Boston Alternative Energy Facility

Applicant's Response to Secretary of State's Letter of 24th April 2023

Planning Inspectorate EN010095

Document Reference: 9.114

Plate 3-1The Point of Maximum Impact of the Facility (blue pin) within The Wash SAC (shown in pink) and the Gridded Background Deposition Rates for Short Vegetation

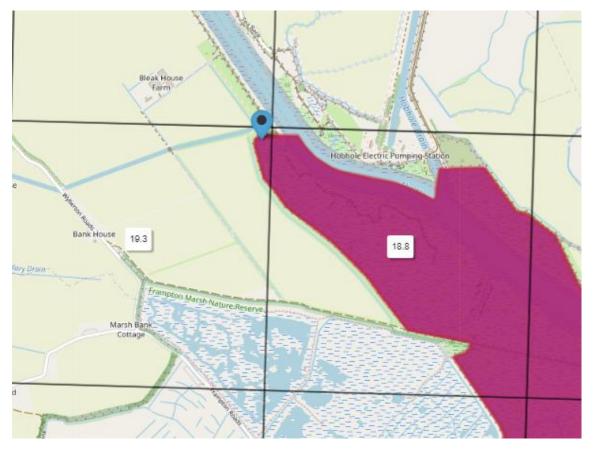
- 3.2.7 The Applicant therefore considers that this point is resolved.
- 3.3 Response to: "A justification of using the "grid average" background concentration to inform the Predicted Environmental Concentration (PEC) at the protected sites"

3.3.3 As shown in **Table 3-6**, the total PEC value using the background deposition rate for short vegetation remains below the Critical Load for saltmarsh habitat. It should also be noted that the background deposition rate cited in the table is within the grid square at which the point of maximum impact of the Facility was predicted to occur, within the northernmost tip of the boundary of The Wash SAC. This is shown in **Plate 3-1**. However, it can also be seen that the background deposition rate reduces in the next grid square, likely due to the increased distance from the Boston urban area and any associated emissions, and therefore the total PEC concentrations set out in **Table 3-6** would occur only over a very small area. With increased distance from the Facility, the Process Contribution (PC) would also reduce, taking the total PEC further below the Critical Load.

3.3.4 For the other sites cited in Natural England's response to which this query applies (Havenside Local Nature Reserve, Slippery Gowt Sea Bank Local Wildlife Site (LWS), South Forty Foot Drain LWS, the Habitat Mitigation Area, and other areas of priority saltmarsh in The Haven), the functionality was not available on APIS to display gridded data across areas outwith nationally or internationally designated sites (the map function has since been updated to include all areas). As such, the background deposition rates for these additional sites as reported in Section 14.7 of Chapter 14 Air Quality of the ES (document reference 6.2.14, APP-052) were obtained by entering the grid reference of the point of maximum impact of the Facility within each area into the 'location search' tool on APIS. To obtain the required deposition rate, the user must enter the habitat type in question (in this instance 'coastal saltmarsh' was selected). The resulting nitrogen deposition rates that are provided by APIS using this method take into account the appropriate deposition velocity for the habitat type selected (i.e. 'moorland'). As such, the deposition rates reported in Chapter 14 Air Quality of the ES (document reference 6.2.14, APP-052) for these sites are habitat-specific and are therefore considered to be appropriate.

3.3.5 Given the above, there is no change to the conclusions of the assessment presented within the Applicant's Response to Secretary of State's Letter of 25th November 2022 (document reference 9.108) and no adverse effect on integrity in respect to air quality and deposition would occur. The Applicant therefore considers that this point is resolved.
